Finalized New Interconnected Crossing Review Report

DOT # 979302J

Park Avenue at Logan Avenue

Renton, WA

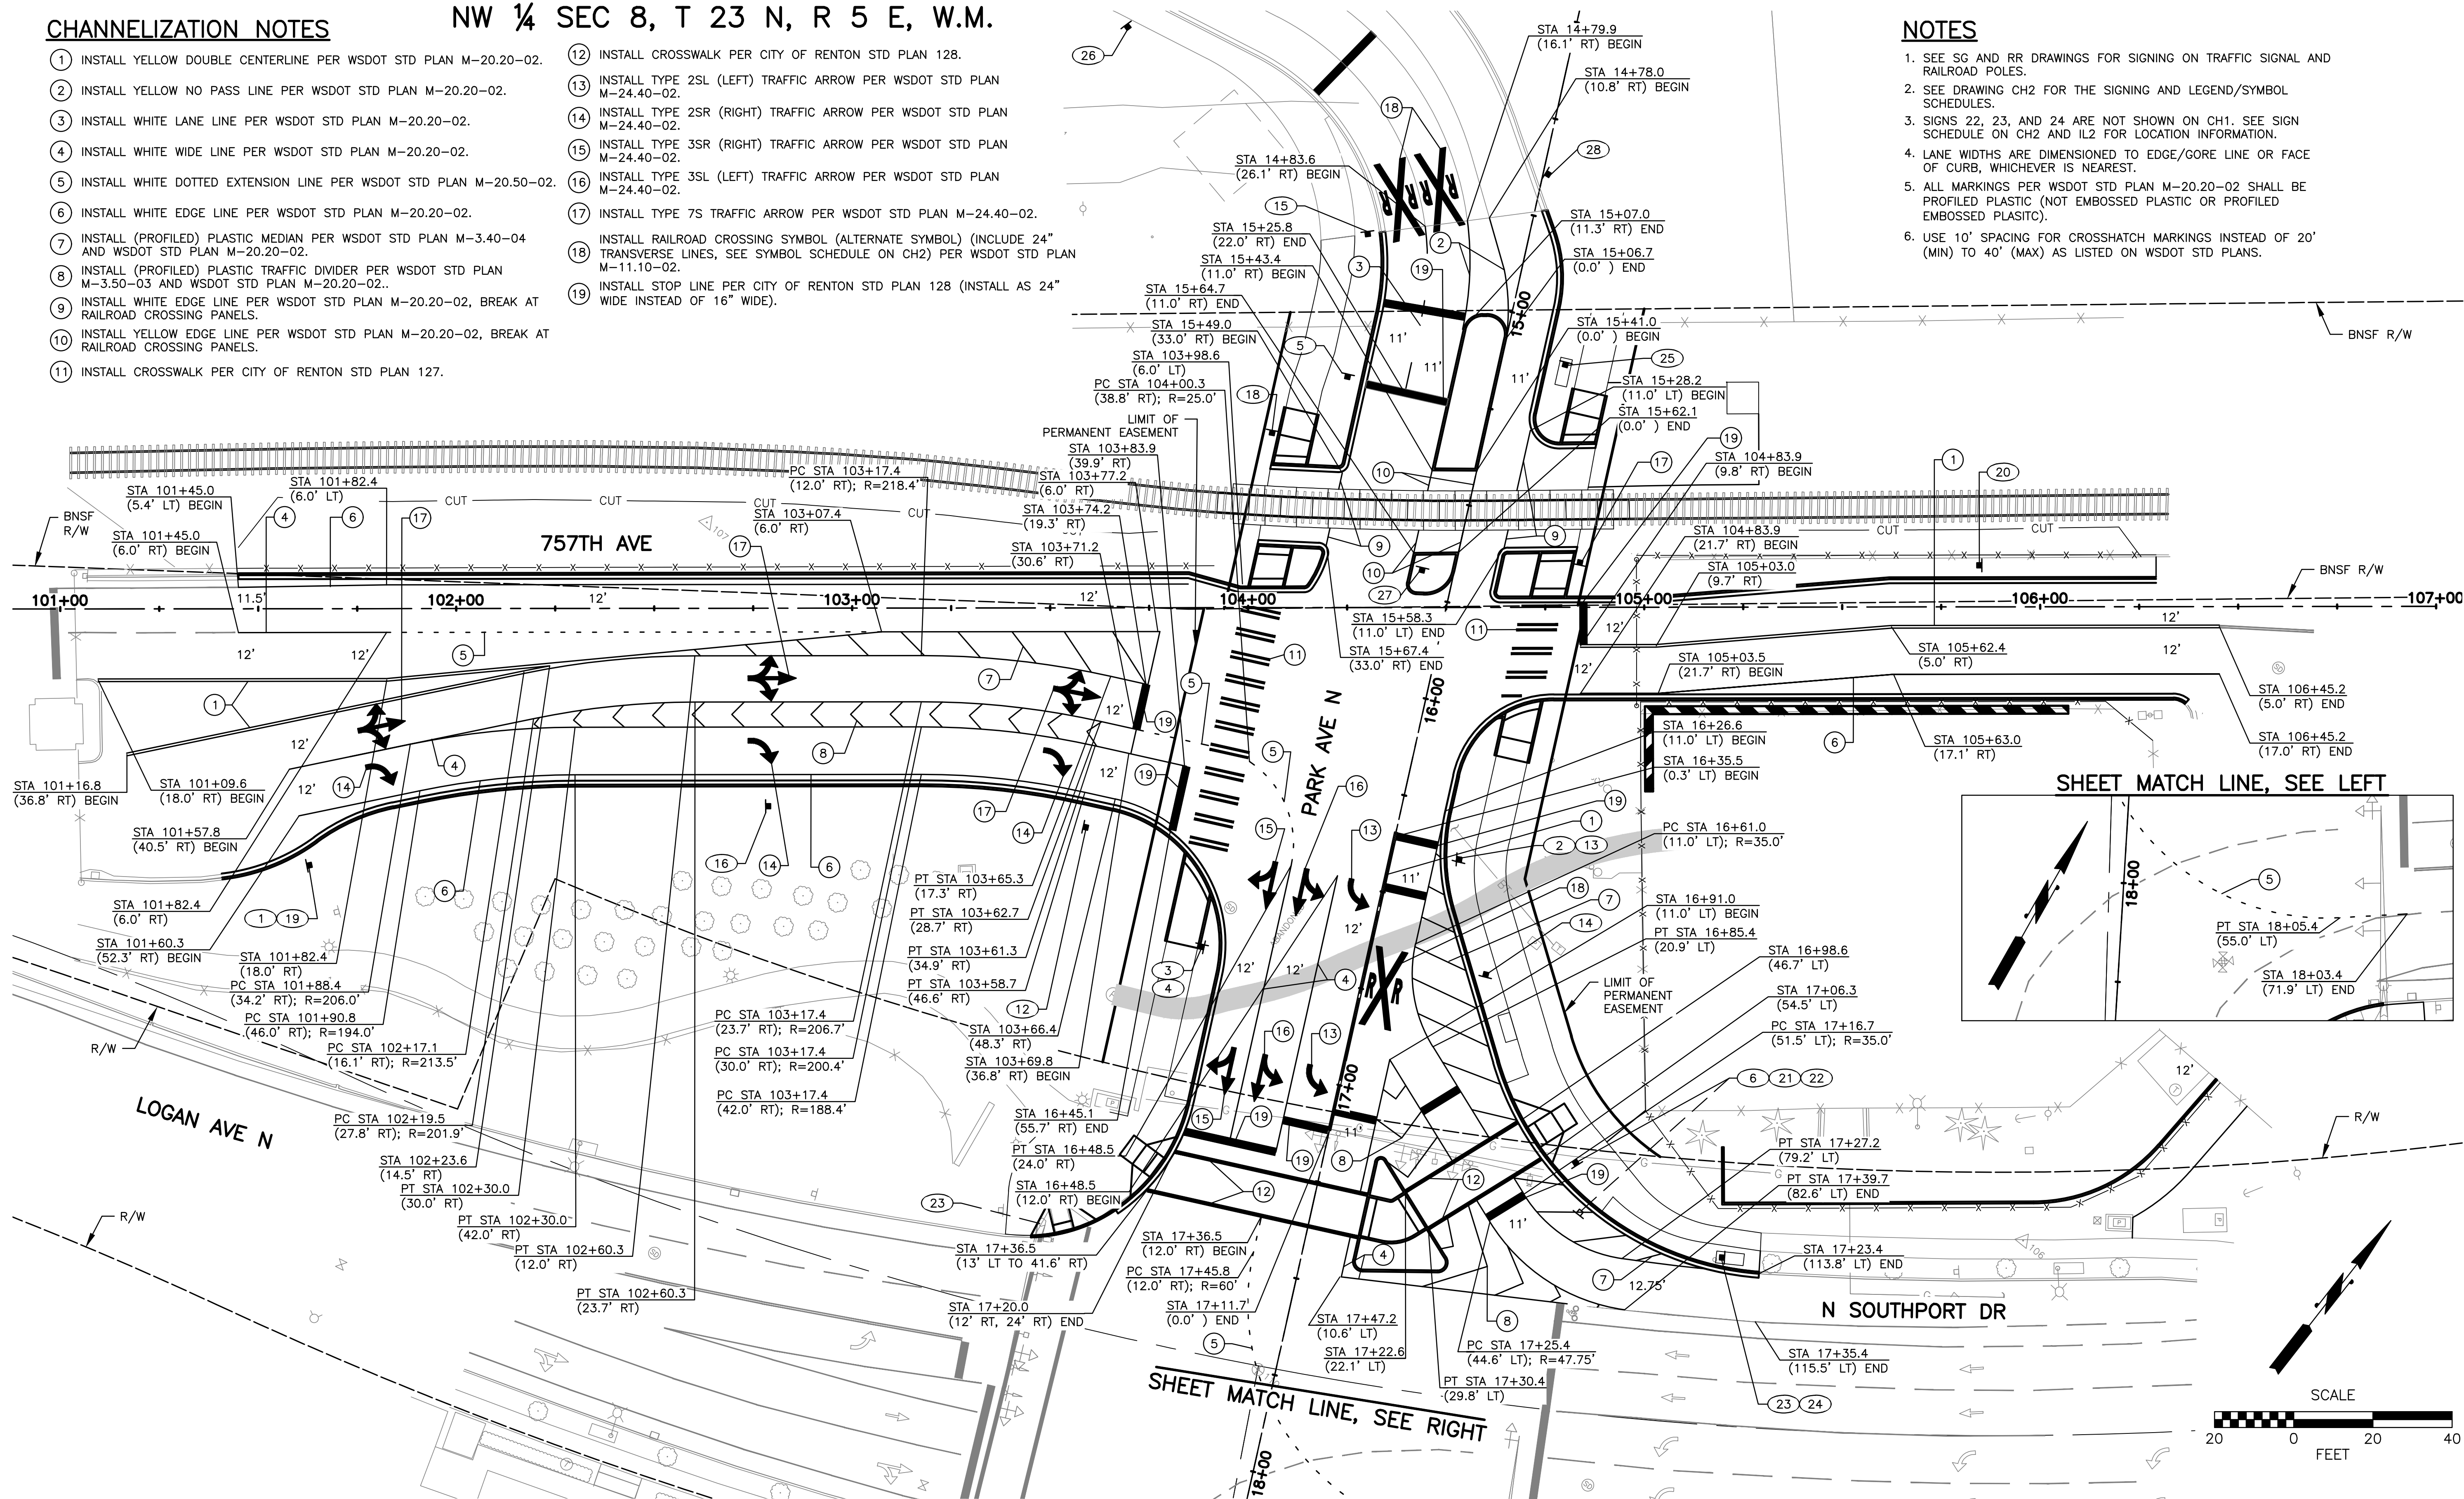
28	Install a W10-2(LT) sign on the eastbound approach along 757 th Avenue to provide adequate warning to motorists of the grade crossing.	MUTCD Figure 8B-6 (2009); MUTCD Table 2C-4 (2009); MUTCD 8B.06 (2009) [Standard]; Standard Practice	Added. See drawings CH1 and CH2.	-	-	-

31	Specify all RxR pavement markings to be installed along with transverse lines per MUTCD and WSDOT standard plan M-11.10-03.	MUTCD 8B.27 (2009) [Standard]; MUTCD Figure 8B-7A (2009) [Standard]; WSDOT Standard Plan M-11.10-03	Revised note text to clarify that transverse lines are included. See drawing CH1, Construction Note 18.	Visually show the RxR pavement marking in plan sheet "G1" to include transverse lines per MUTCD standards and WSDOT standard plan M-11.10-03.	Now shown on plan sheet G1.	-
32	Verify that any proposed signage near the grade crossing will not block motorists' visibility of RR flashers at any time.	AREMA C&S Manual 3.2.5 Section C.7 (2021) [Guidance]; Standard Practice	Verified.	-	-	-
33	Consider installing median striping between the grade crossing panels and the median to discourage motorists from turning onto the tracks.	Recommended Practice	Added. See drawing CH1.	-	-	-

34	Consider adding lane line extension striping for the southbound dual left-turn from Park Avenue onto Southport Drive.	MUTCD 3B.08 (2009) [Guidance]; Recommended Practice	Added. See drawing CH1.	-	-	-
35	Specify limit lines to be 24" wide for roadway approaches leading towards the grade crossing.	Standard Practice; WSDOT Standard Plan M-11.10-03	Stop lines for roadway approaches revised to 24". See drawing CH1.	-	-	-
36	Consider installing edge line striping to channelize motorists through the grade crossing and discourage any turning onto the tracks.	MUTCD 8D.04 (2009) [Option]; Recommended Practice	Added. See drawing CH1.	-	-	-
37	Consider installing R3-2 "NO LEFT TURN" blankout signs for eastbound traffic on 757 th Avenue to restrict turns towards the crossing during a preemption event.	ITE Recommended Practice: Preemption of Traffic Signals Near Railroad Crossings Part 2.4.6 (pg. 42-43) (2021) [Guidance]; MUTCD 8B.08 (2009) [Guidance]/[Option]; Recommended Practice	Have decided to not install blank-out sign due to controller limitations.	-	-	-

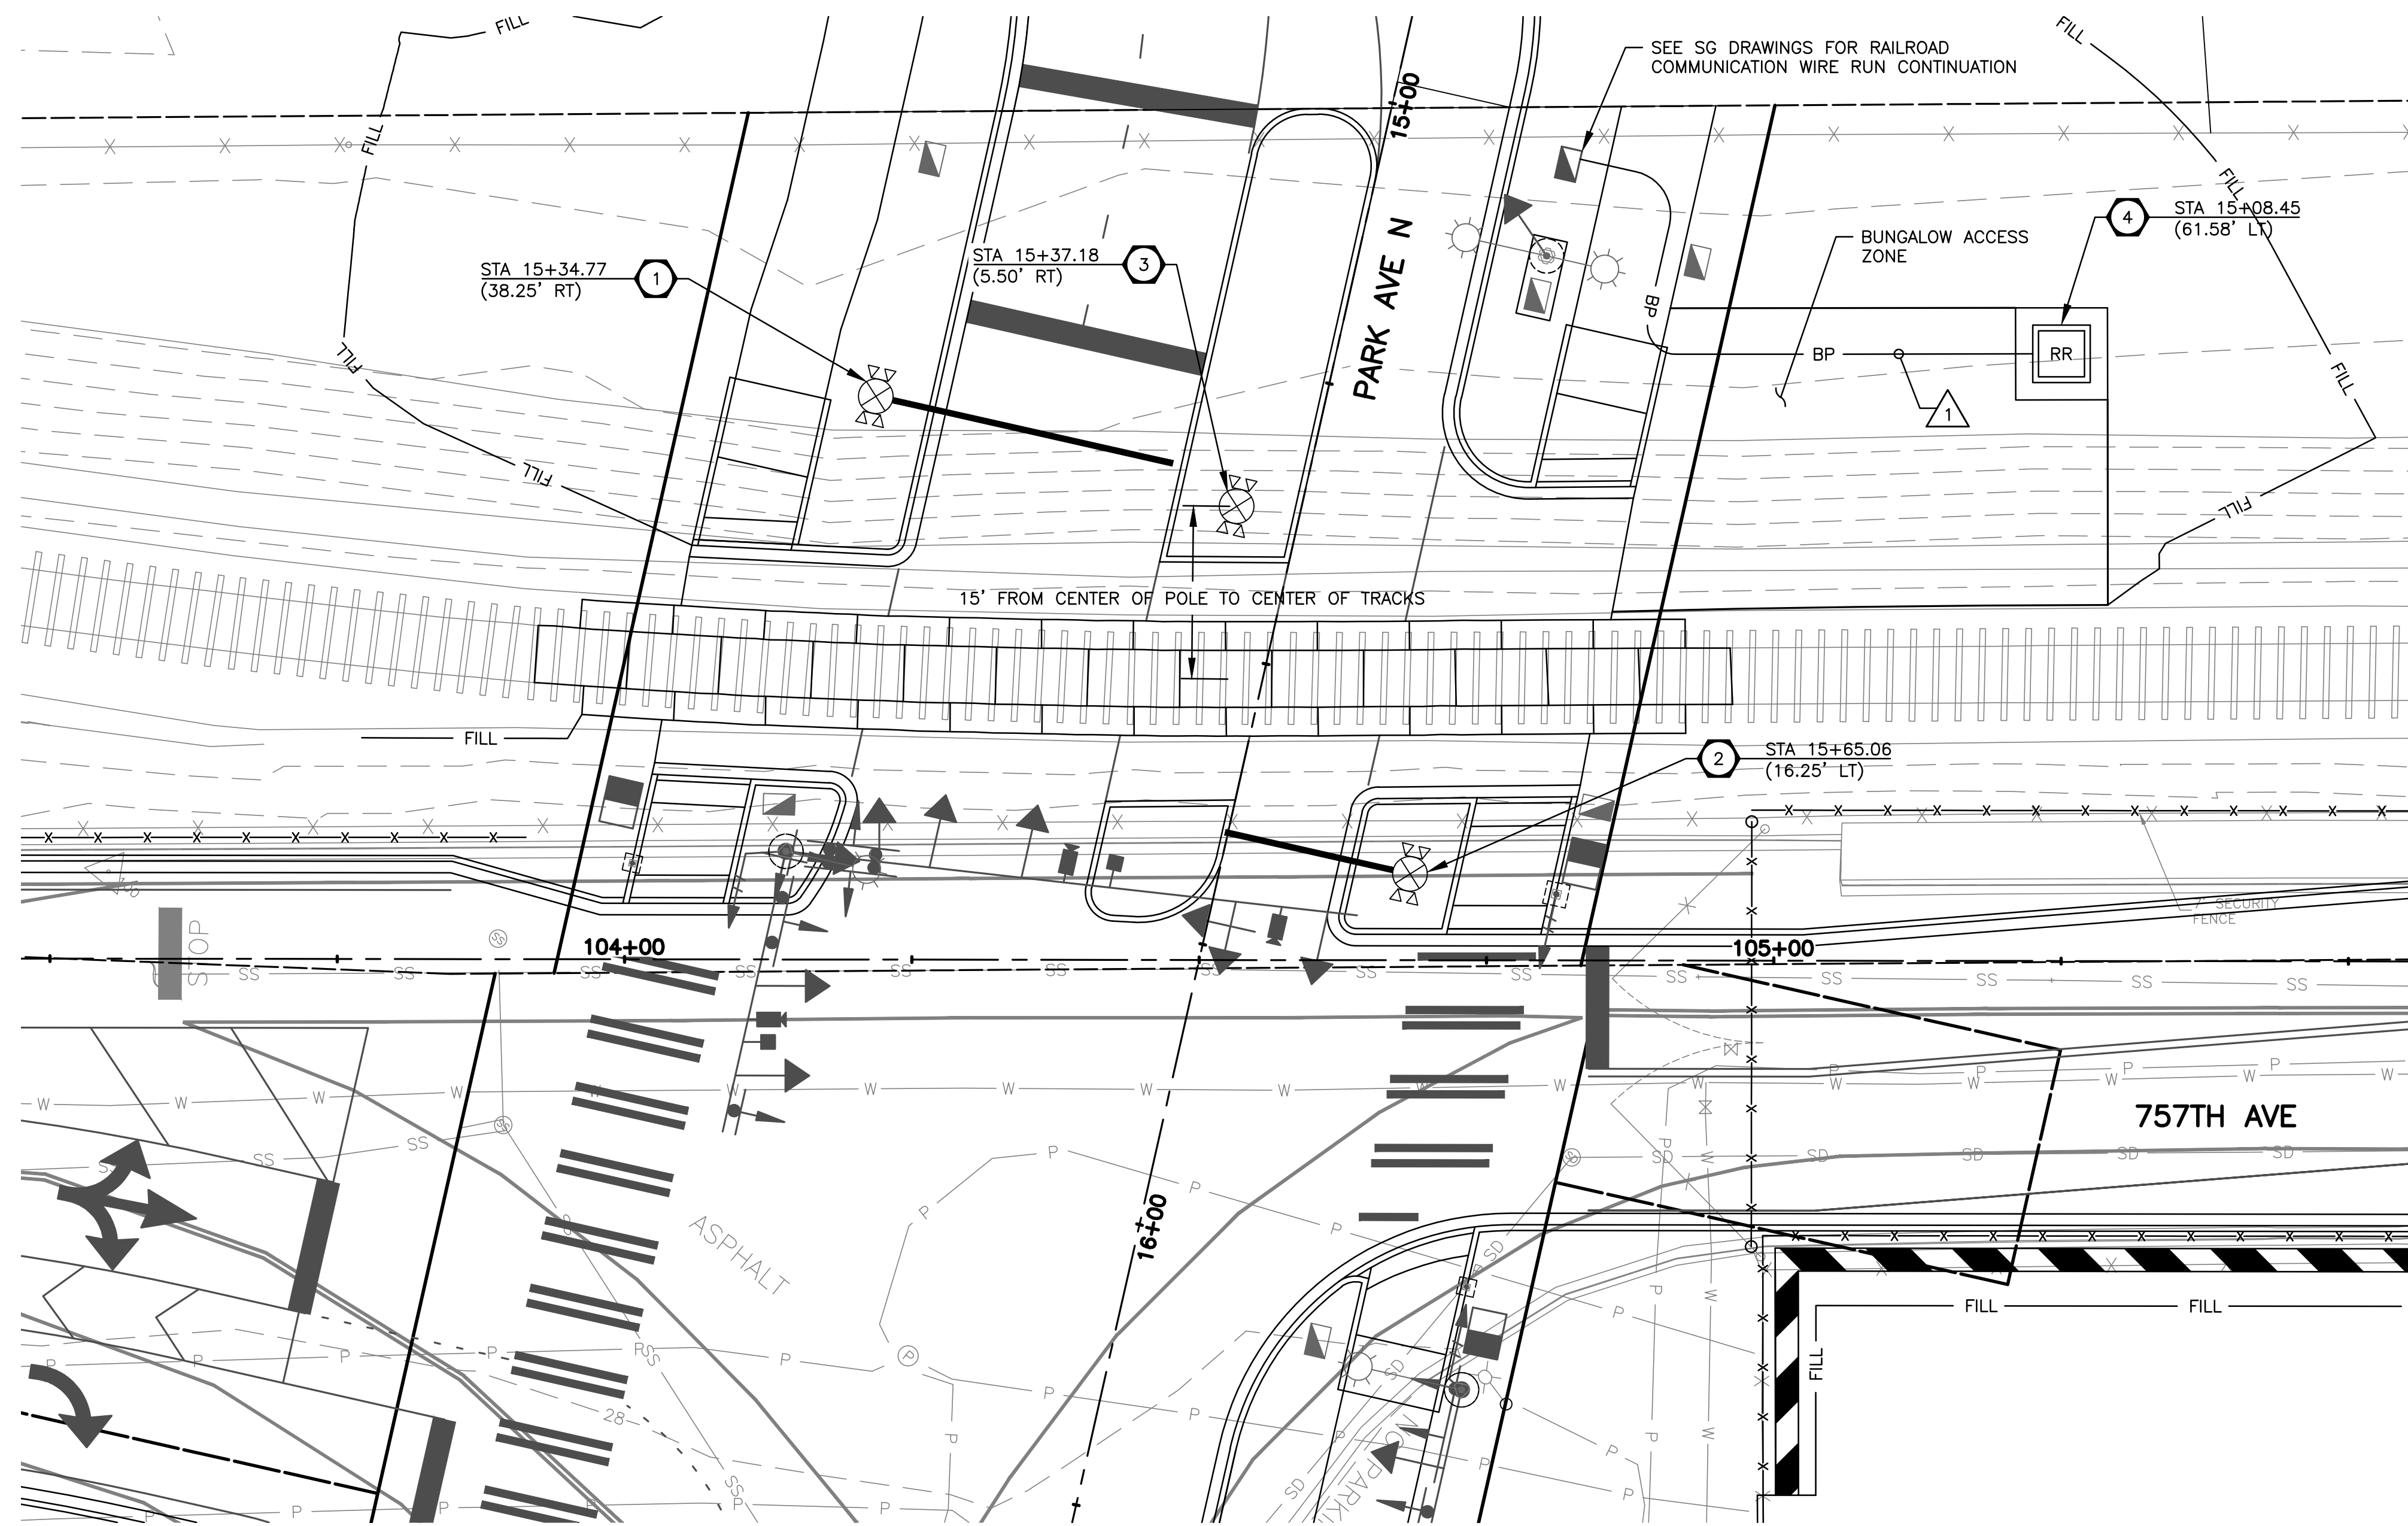
12	RR gate lengths should be measured from the gate tip to center of RR gate mechanism. Please revise dimensions shown accordingly.	BNSF Standard	Revised. See drawing RR1.	Gate lengths should be measured from the center of the RR gate mechanism, not the edge. Revise dimensions and construction notes in plan sheet RR1 accordingly. Revise BNSF Crossing Layout plan sheet to stay consistent with plan sheet RR1.	Revised.	-
13	Specify lane widths at the grade crossing on plans.	Standard Practice	Specified on drawing CH1.	Revise BNSF Crossing Layout plan sheet to stay consistent with plan sheet CH1.	Revised.	-
14	In the raised median north of the crossing, specify the RR warning device to be 15' from centerline of track.	BNSF Standard	Station provided on drawing RR1 provides 15' clearance from centerline.	Specify 15' from center of RR gate mechanism to centerline of tracks on plan sheet RR1. Revise dimension on "BNSF Crossing Layout" plan sheet to stay consistent with plan sheet RR1.	Revised.	-

The group agreed to remove the proposed gate pole (shown as Pole #3 in the 90% Plans on drawing RR1) south of 757th Avenue.
